January 22, 2019
A14D7067-1

**RE: Streets of West Pryor
Final Plat
First Submittal Comment Response**

DECEMBER 19, 2016
7067EXBF_RW VAC

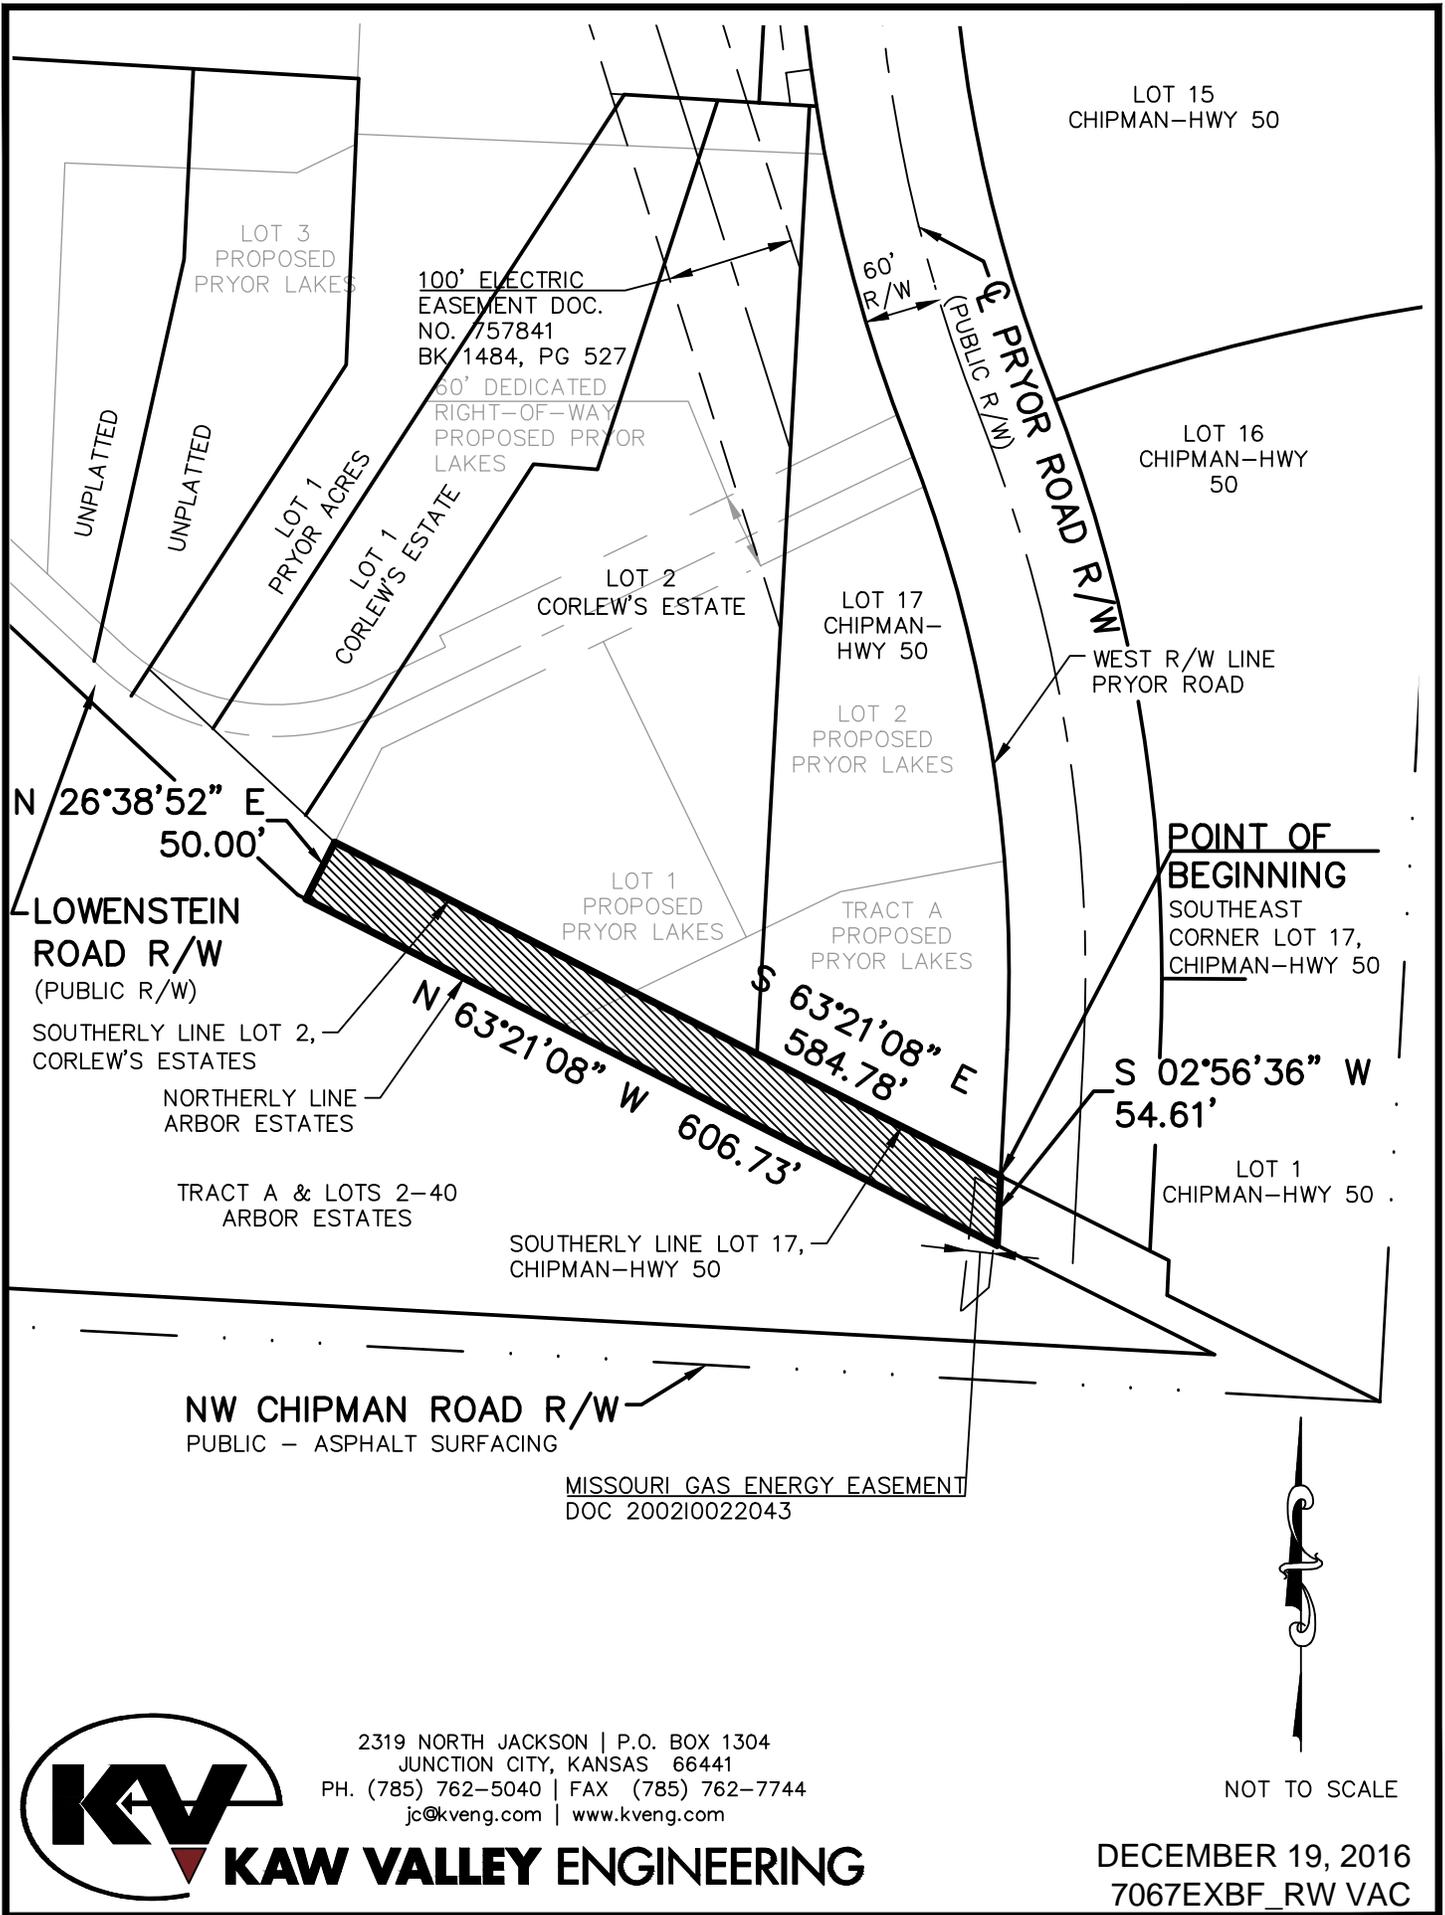
2. The plat should show the ROW and easements located at the intersection of Pryor and Chipman, where a vacation of ROW is proposed, to ensure that remaining ROW and easements adequately include existing and future roadway, sidewalk, signal and lighting improvements, or such ROW dedication may be shown the plat as necessary.

Existing ROW and easements are shown on plat – See attached Exhibit of ROW vacation.
